**Shire Valley Transformation Program-1 (SVTP-1).Construction of Main Canal 1 (MC1) and Main Canal 2 (MC2)**

21.09.2020

Type of Main Canal 2

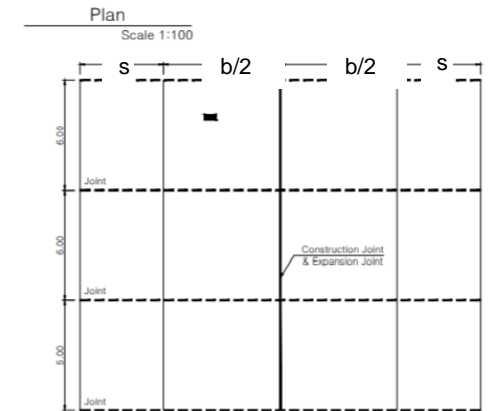
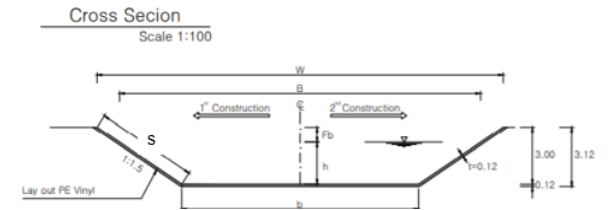
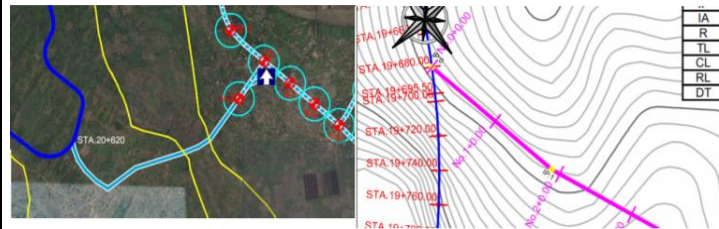
1. Calculation of Quantities of Main Canal 2 is wrong as per the formula, kindly clarified.

Some errors are required corrected as below

Construction joint interval : 60 - 90m

$B-180 = (s \times 2 + b) \times 0.12 \times 1.0$

$Wire\ mesh = (s \times 2 + b - 0.5 \times 4) \times 1.0$

$PE\ Vinyl = (s \times 2 + b) \times 1.0$

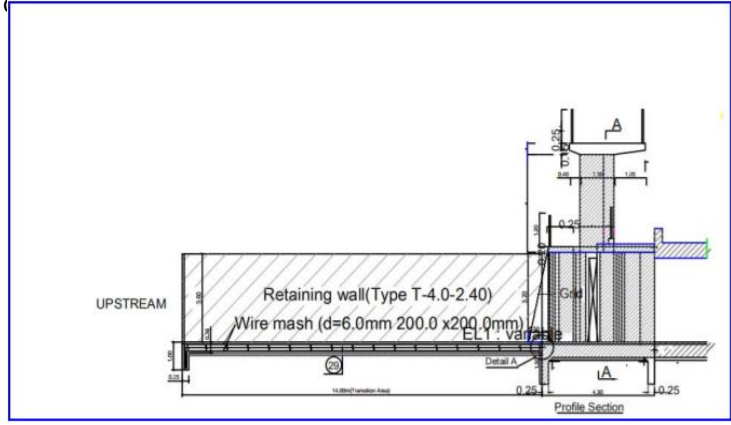
2. Starting Point of water supply pipe on shown MC1 STA.20+620 as below, however, the starting point of inlet water is STA.19+660, which one is correct?

STA.19+660 is the right one.
